FREQUENCY CENTRAL

Addendum to build doc for:

METH AMP

Based on the Pro-One ADSR, featuring CEM3310 or AS3310 chip

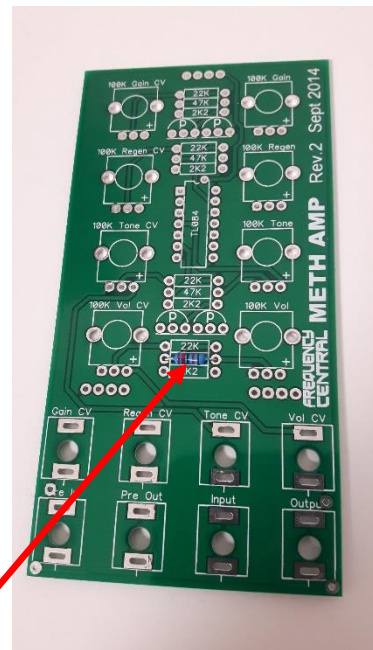
To create a firmer physical connection between the two PCBs, cut headers as shown below:
